Product Change Notification

110660 - 01

Change Notification #: 110660 - 01
Change Title: Intel(R) Server Chassis P4304XXSFCN, Single, Intel(R) Server Chassis P4304XXSHCN, Single, PCN 110660-01, Product Design, Product Design, Chassis design improvement, Reason for Revision: Updated products affected table
Date of Publication: July 20, 2011

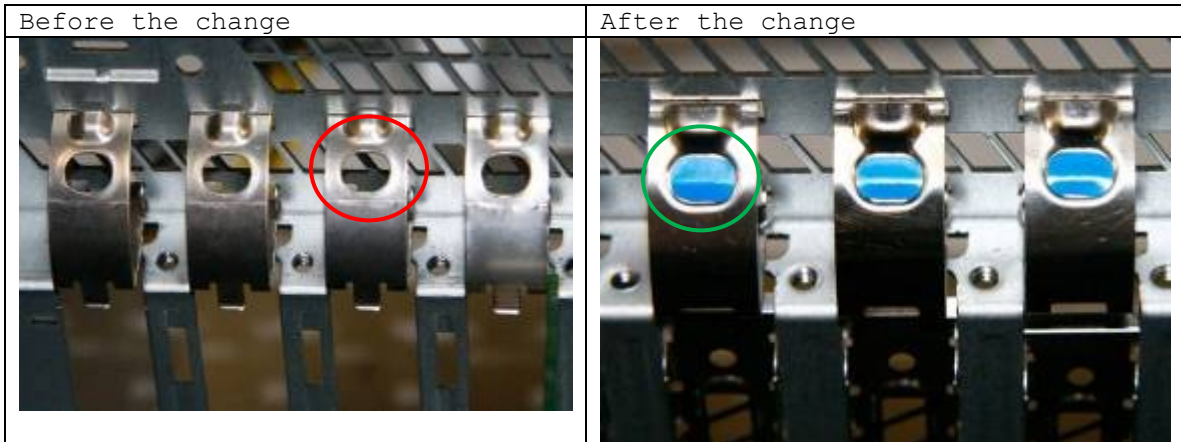
1.1 Adjust the bottom cable clip location for cables. The following is a picture of the change:

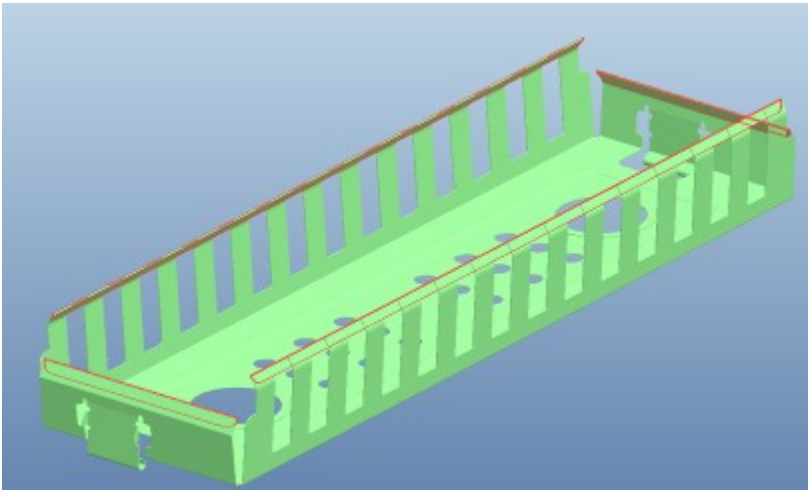
1.2 Fill the PCI retainer hole with an embossment, and add a blue Mylar on the embossment to indicate a user access point. The following are pictures of the prior and post change:

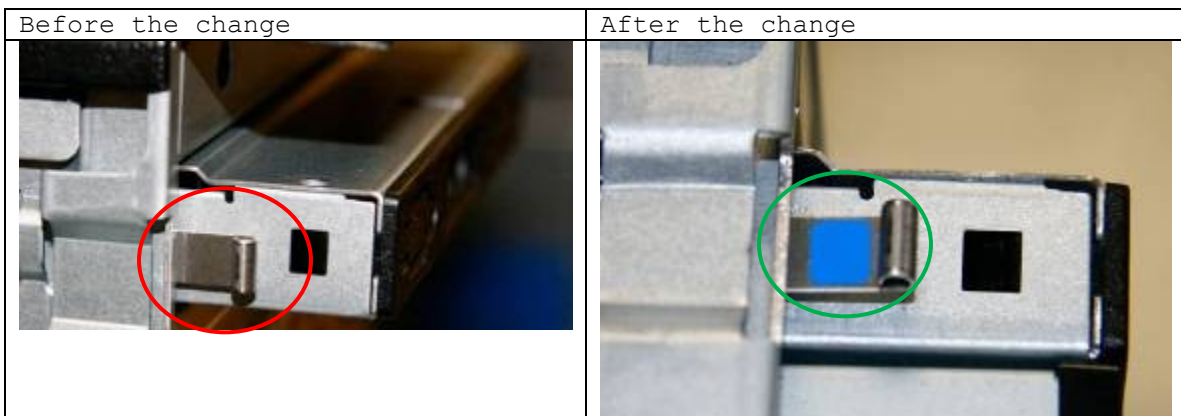
1.3 Add a hem on all edges of Optical Disk Drive (ODD) EMI cover. The following is a picture of the change:

Remove the cable clip

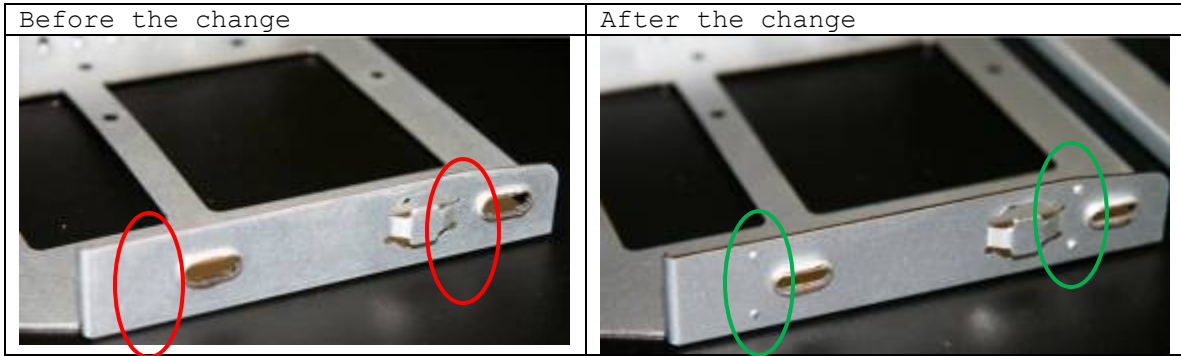
2.1 Remove the redundant cable clip near the front panel. The following picture shows the clip that will be removed:

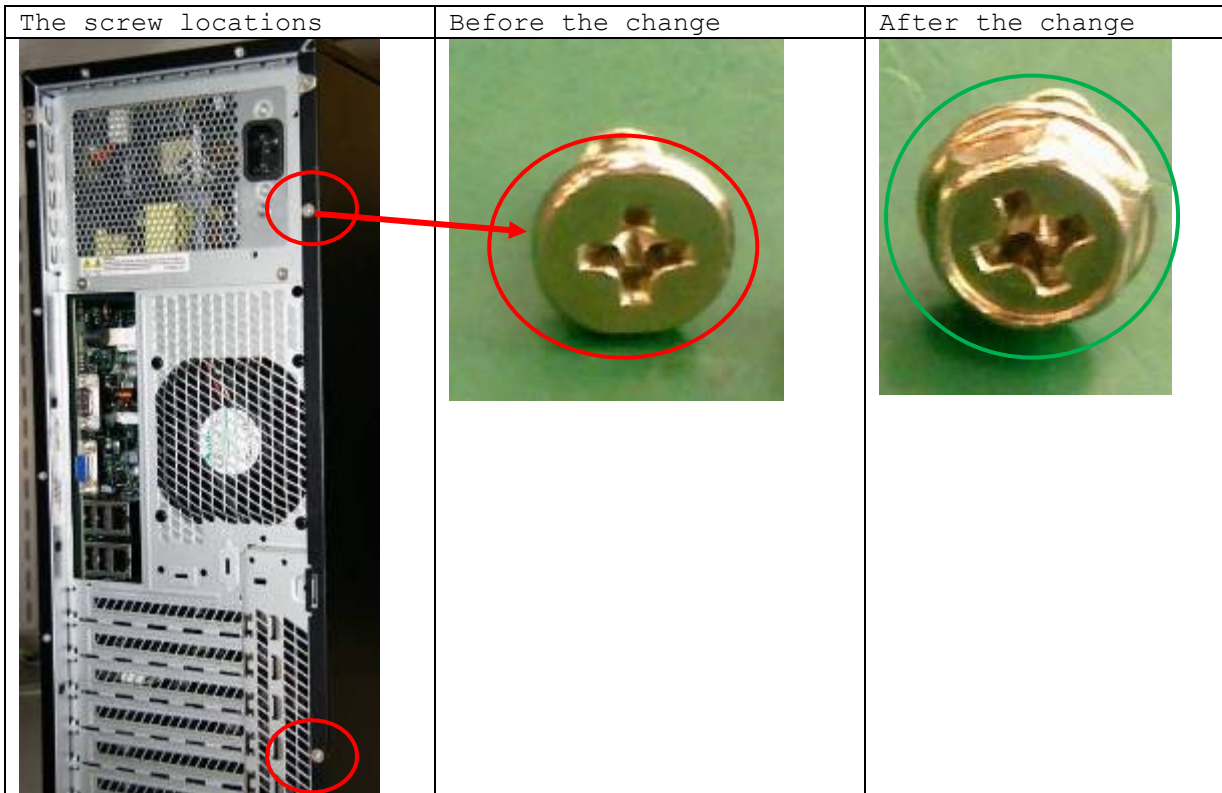
2.2 Add dimples on the fixed hard drive tray to improve the tray lock mechanism. The following are pictures of the prior and post change:
